PECOS DISTRICT DRILLING CONDITIONS OF APPROVAL

**ALL PREVIOUS COAs STILL APPLY. CEMENT DESIGN UPDATE AS PER
KPLA BEST PRACTICES (4-STRING INT1 X INT2 OPEN ANNULUS)**

OXY USA INCORPORATED		
BATCH SUNDRY ID: 2698966		
PRECIOUS 30-18 FEDERAL COM	3H	3001546350
PRECIOUS 30-18 FEDERAL COM	32H	3001546611
PRECIOUS 30-18 FEDERAL COM	43H	3001546614
PRECIOUS 30-18 FEDERAL COM	44H	3001546544
PRECIOUS 30-18 FEDERAL COM	171H	3001546581
PRECIOUS 30-18 FEDERAL COM	172H	3001546582
PRECIOUS 30-18 FEDERAL COM	175H	3001546457
PRECIOUS 30-18 FEDERAL COM	176H	3001546462

Precious WCXYA Bulk Sundry

Figure C] 4 – String – Un Cemented Annulus

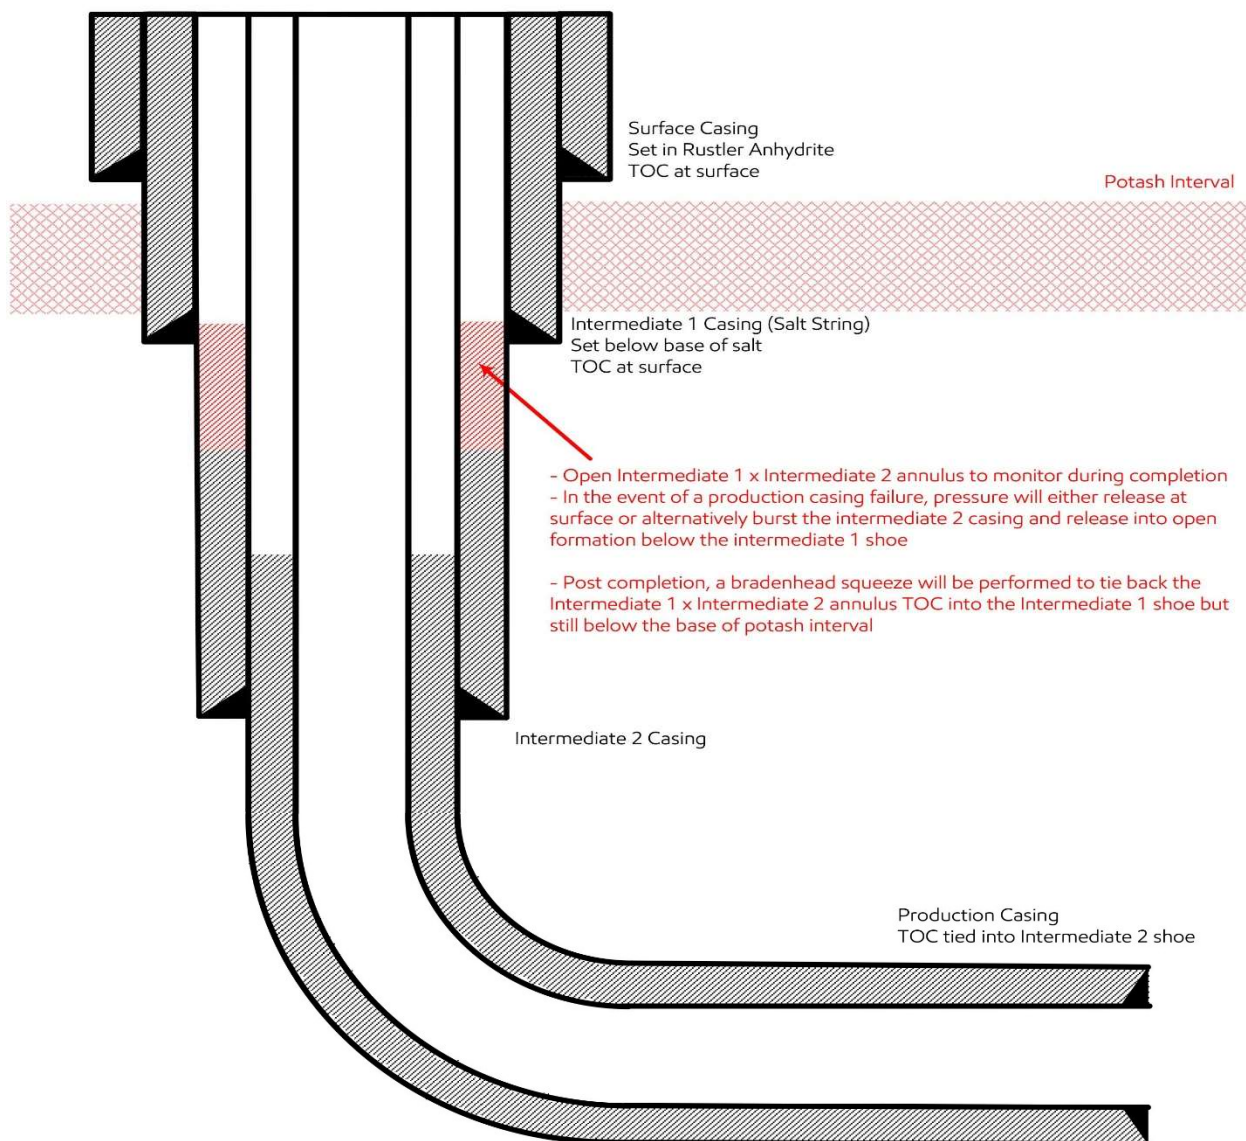
Operator has proposed to pump down 7-5/8" X 9-5/8" annulus POST-FRAC. Operator must top out cement after the bradenhead squeeze and verify cement to surface. Operator can also check TOC with Echo-meter. CBL must be run from TD of the 7-5/8" casing to surface if confidence is lacking on the quality of the bradenhead squeeze cement job. Submit results to BLM.

Oxy requests to update the Deep Intermediate Cement Job to align with the agreed upon R111-P updates presented from the JITC. (Below table based on Precious 30-18 Fed Com 175H)

- Cement to surface. **AS PER MODIFIED DESIGN, THIS CAN BE ACCOMPLISHED POST-FRAC. Wait on cement (WOC) time for a primary cement job is to include the lead cement slurry due to cave/karst or potash.**
